Cameron Balloons US Service Bulletin 11

1	General	
(a)	Number	11
(b)	Revision / Date	0 / 1 JUN, 2025
(c)	Title	PRV Adaptor CB8426 for Legacy Fuel Tanks (Cylinders)
(d)	Description	Inspection and possible replacement of adaptors in service based on pass criteria.

Figure 2
Cracked CB8426, PRV Adaptor

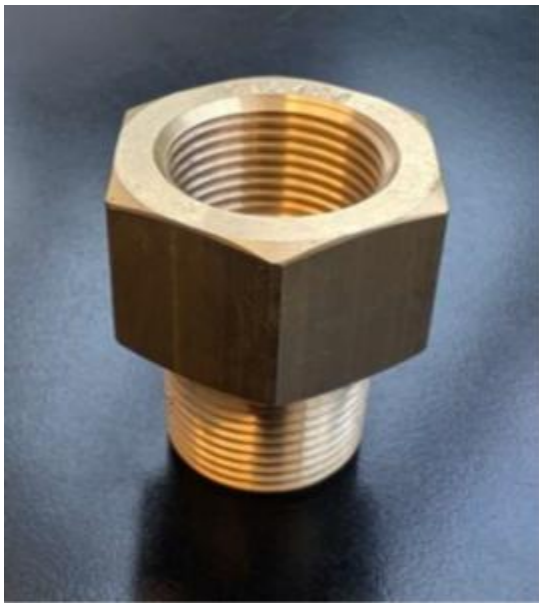
Failed components have presented with a crack located on the upper hex portion of the adaptor (see figure 2).

3	Compliance (Category) Required on receipt of this bulletin.
4	Consequences of Non-Compliance (Possible) Uncontrolled leak of LPG fuel.
5	Accomplishment Instructions Affected PRV adaptors installed in fuel tanks (cylinders) must be visually inspected for cracks within 24 hours of receipt of this bulletin. Any fuel tanks found to have cracked adaptors installed should be emptied of fuel immediately. Contact Cameron Balloons US in the event of the discovery of a cracked adapter. Affected PRV adaptors found without cracks can continue to be used for flight but must be inspected before each flight. Adapters supplied by CBUS that do not have the "CB8426" stamp do not need to be further inspected. These instructions can be performed by the pilot/owner.
6	Materials: None
7	Other Publications Affected: None
8	Mass (Weight)/Balance: Not affected
9	Maintenance and Operating Instructions: Not affected
10	Additional Information: For any questions concerning the technical content of the requirements in this Service Bulletin, please contact: <div style="text-align: center;">Cameron Balloons US 7399 Newman Blvd Dexter, MI 48130 email: tech@cameronballoons.com Phone: +1 734 426 5525</div>
